RE: STATE SIGNIFICANT DEVELOPMENT APPLICATION (SSD 9601) FOR PROPOSED PLANT 2 UPGRADE WORKS

PROPERTY AT: 780 WALLGROVE ROAD, HORSLEY PARK (LOT 7 DP 1059698)

Table 1: Response Matrix	
Relevant Entities Response to Submissions	Formalised Response
NSW Department of Planning, Industry and Environment (Chris Ritchie – Director – Industry Assessments)	
<p>Process Description:</p> <p>1. The Department notes there will be no changes to the existing operations of the Plant 2 facility. However, the EIS should detail the operational processes of the facility to provide context for the proposed development. The Department requests the Response to Submissions (RTS) clearly detail the individual processes and stages of brickmaking production including the functions of machinery. The Department recommends preparing a figure/ process diagram that clearly illustrates the brickmaking process of the Plant 2 facility.</p>	<p>It is noted, that the production process for brickmaking on the Subject Site comprises five (5) operational stages, including:</p> <div style="text-align: center;">  <pre> graph LR A[Raw Material Preparation] --> B[Shaping] B --> C[Drying] C --> D[Firing] D --> E[Packing] </pre>

Figure: 2018 Pacific Environment meteorological data (Left) and 2019 Airlabs Environmental meteorological data (Right).

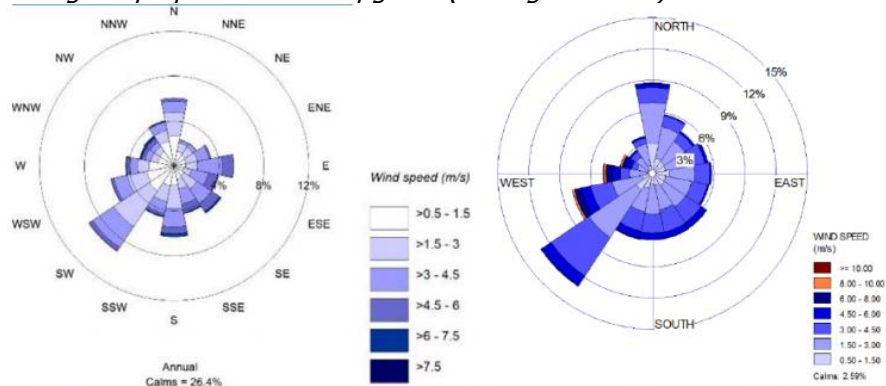
The EPA notes that the 2018 AQIA (Pacific Environment, section 4.3) shows different wind fields and a much higher % of calms than the AQIA report modelling the proposed Plant 2 upgrade (see Figure below).

The EPA advises that the significant inconsistencies of meteorological data by the same proponent is questionable and that the significant difference in the percentages of calm would influence the dispersion of emissions, potentially changing the results and conclusions of the assessment.

The EPA recommends that a revised AQIA be prepared that demonstrates the meteorological data used for dispersion modelling adequately describes the expected meteorological patterns at the site.

Airlabs wish to inform the NSW EPA that technical inaccuracies were identified in the CALMET model developed in the original Air Quality Impact Assessment. The inaccuracies were in relation to the percentage of calms predicted by CALMET. This has since been addressed in the revised meteorological model developed by Airlabs and a detailed discussion on the validity of the meteorological model output has been presented.
